re Carver
Auto Sales
1328 Point Douglas

September 14, 2018

RE; Illegal to issue a license to expand a commercial use in a protected area of the River Corridor

SITE PLAN C2-1

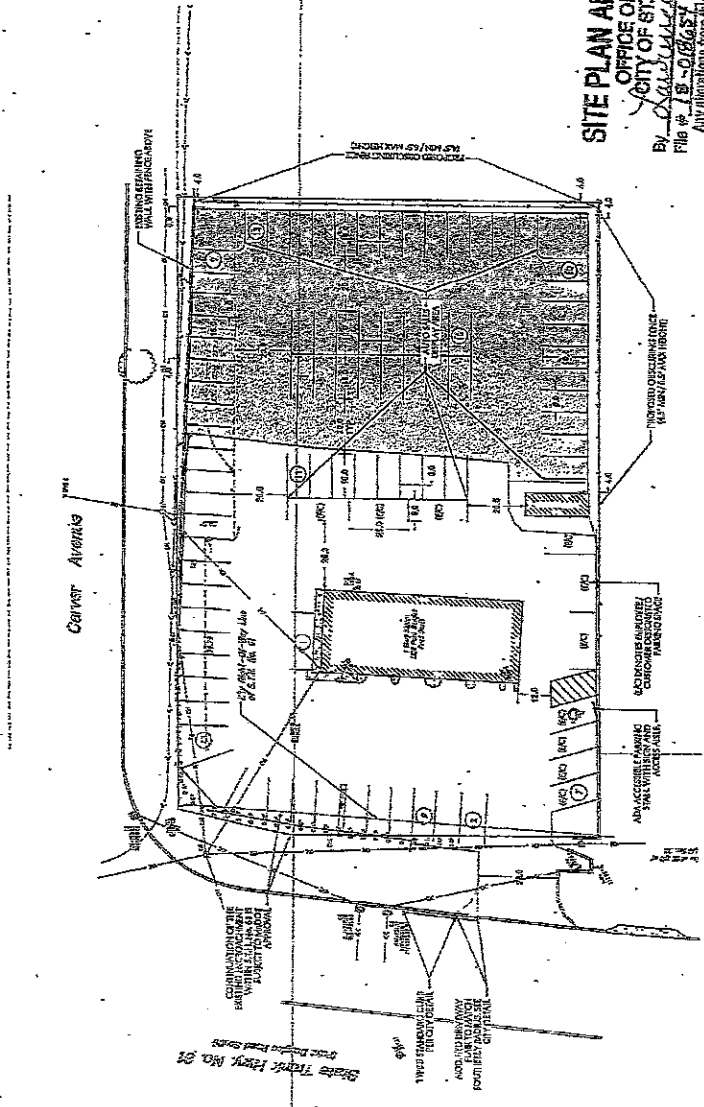
The site plan tied to the proposed license states that no person shall maintain any projection or encroachment within the public right of way. Photos and the plan indicate encroachment within the public right of way. A license should not be issued for a plan indicated to be non compliant.

The zoning code requires a 4 feet setback and screening on all sides that abut residential zoning. There is RL Zoning on the north, east, and south sides. RL zoning is the most protective residential zoning in Saint Paul and this property is in a protected State Critical Area, and a National Park. The submitted plan does not provide a setback or screening for much of the south side and no setback or screening on the north side of the property. Vegetation screening is appropriate in river corridor district and Great River Passage Plan that emphasis for more natural. A license should not be issued for a plan indicated to be non compliant.

The zoning code requires interior landscaping for more than twenty parking spaces or six thousand square feet of paving. The zoning code requires fifteen square feet of interior landscaped area for every one hundred square feet of paving. A license should not be issued for a plan indicated to be non compliant.

The zoning code requires at least one shade tree planted for every 5 parking spaces. In a district with a tree preservation requirement, a license should not be issued without meeting the tree requirement.

The zoning code requires a perimeter landscaped buffer four feet wide along the street sides of the property. A license should not be issued without the required landscaped buffer of the north and west.
